November 19, 2019

Project 171.05027.008

Re: Nordic Aquafarms, Inc
Request for Additional Information (2)
File No. NAE-2019-01481

CS101 - 5

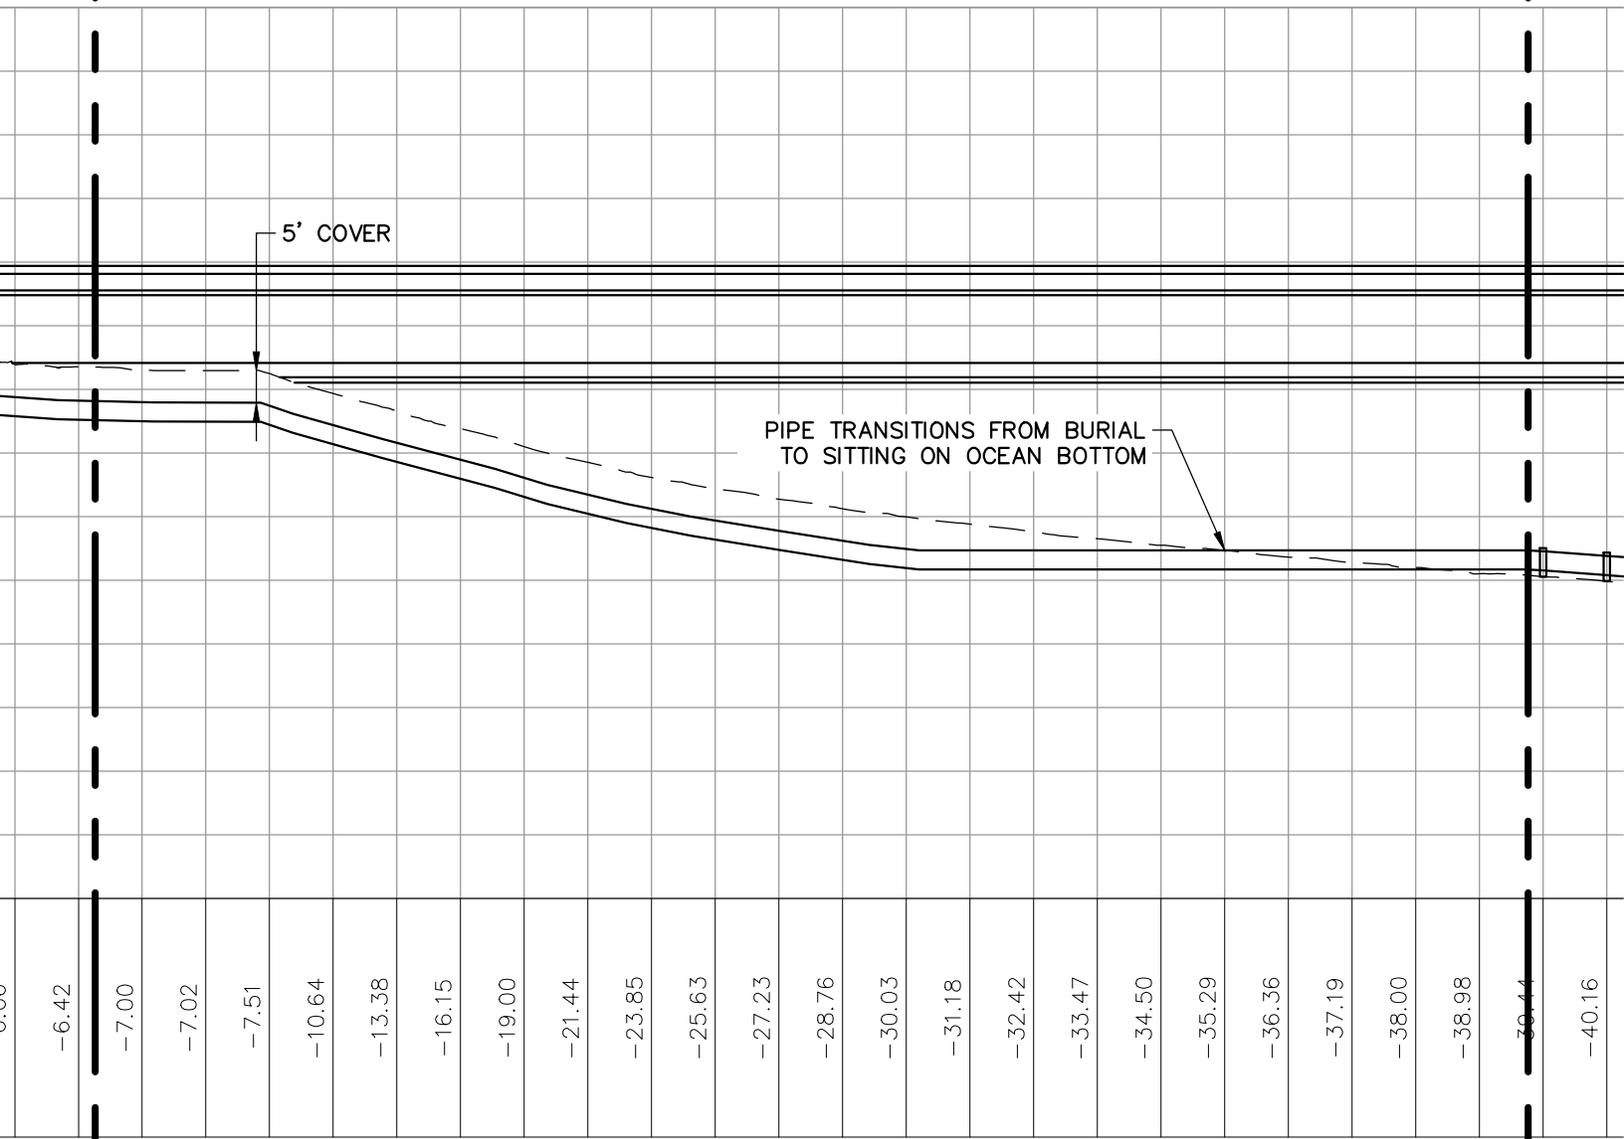
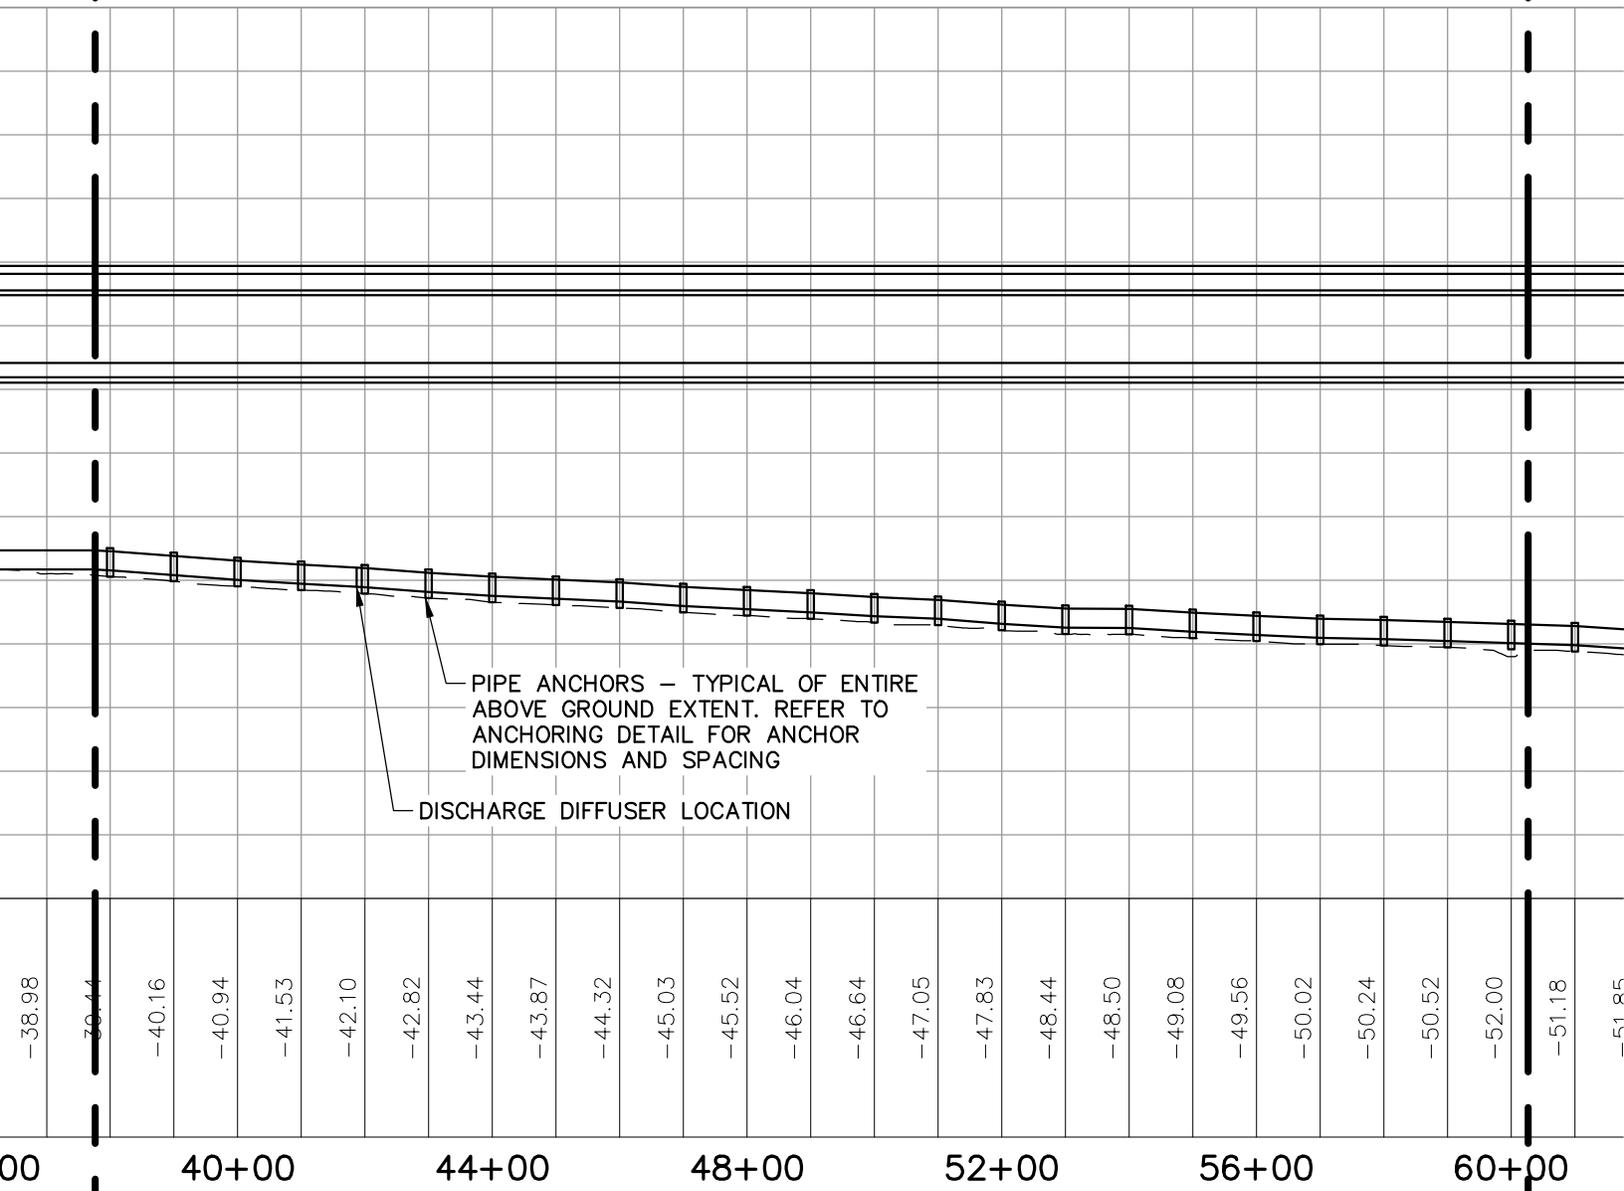
6. Attachment D. Sheet CS-101. I need a reduced 8 ½ x 11 version of this plan. Given the length this can be on 2 sheets, one of the Plan views with a match line and Cross Section with a match line or both views with a match line. Like Sheet 2 of 2 (Item 4) this should also show the High Tide Line along the shore.

The reduced plan is attached as Attachment 6, which shows the High Tide Line as requested. Note that construction mats are now shown on the drawing for work to be conducted in the intertidal zone. The construction mats will be placed in a linear fashion along the planned trench, and removed when not in use,

CS501 Plans

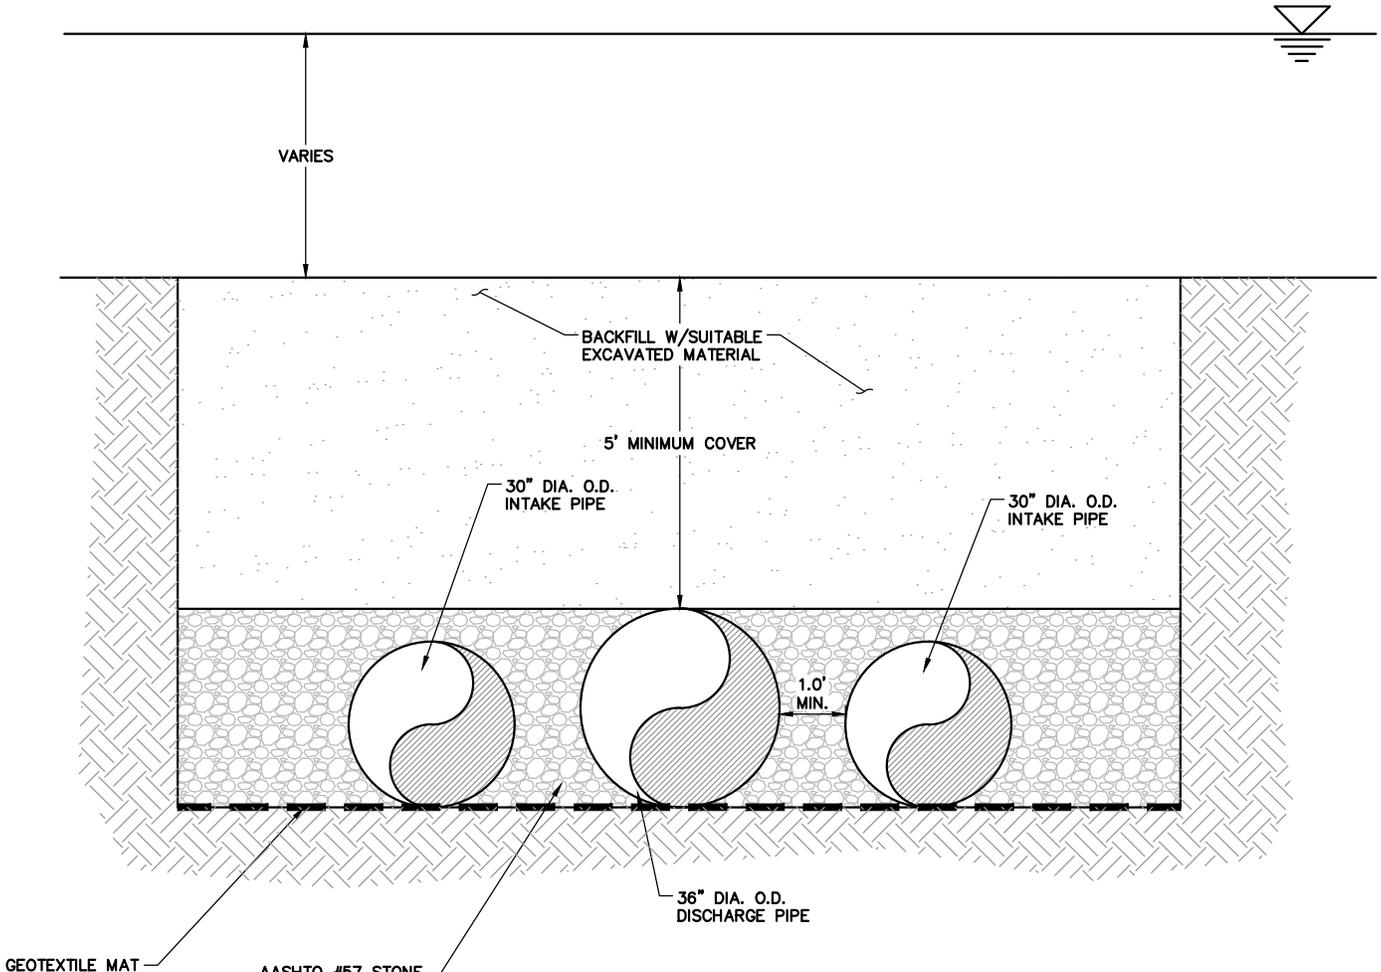
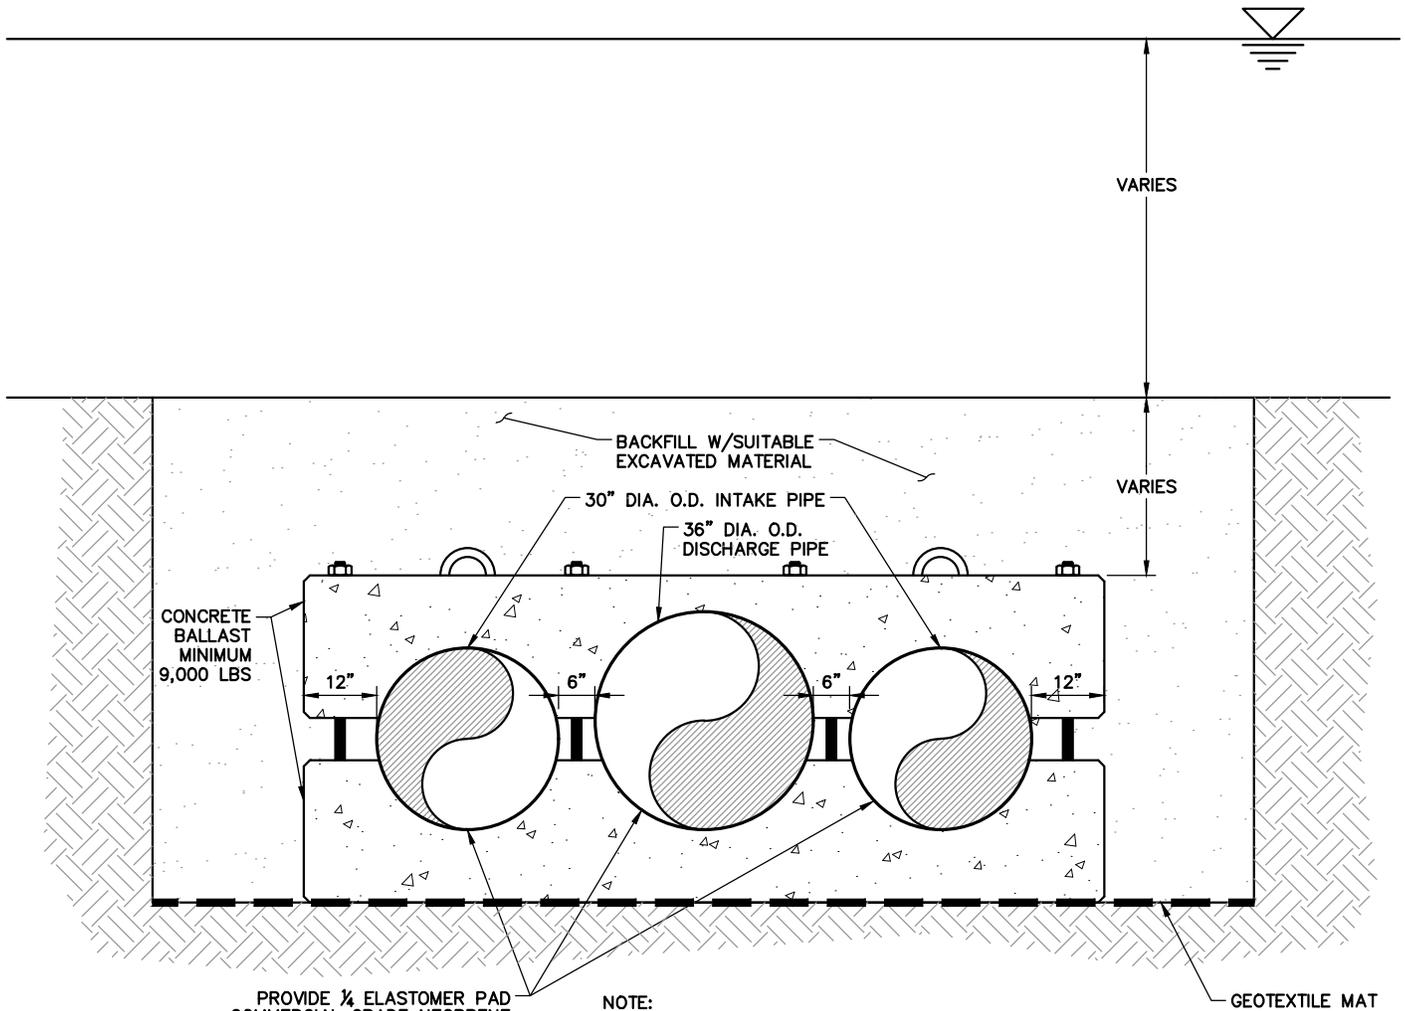
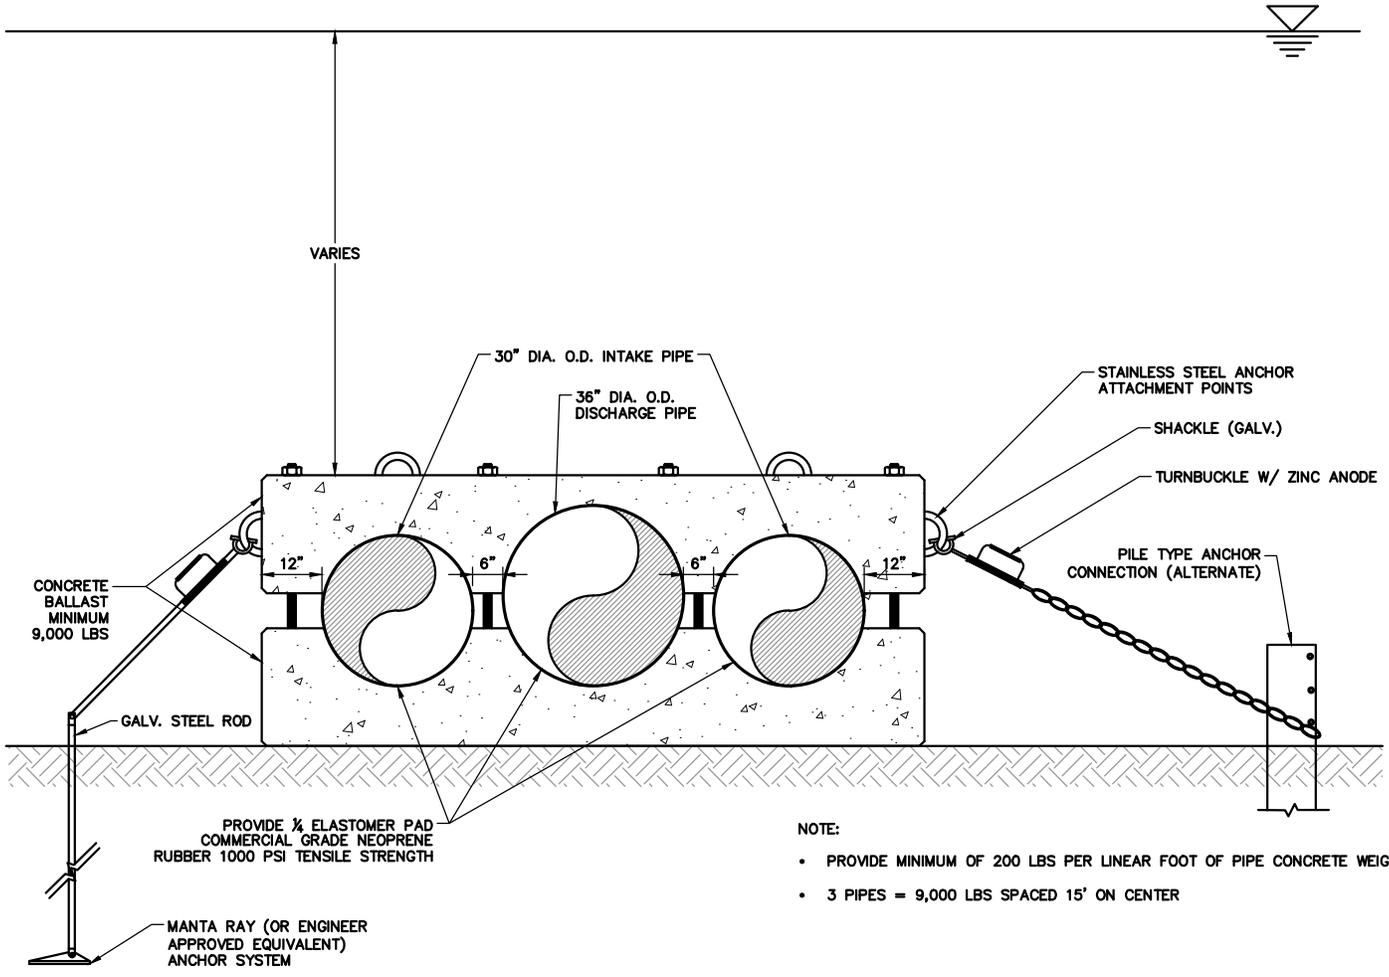
9. Please provide 8 ½ x 11 drawings of CS501 anchoring plan.

An 8 1/2 x 11 drawing of CS501 is attached as Attachment 9.
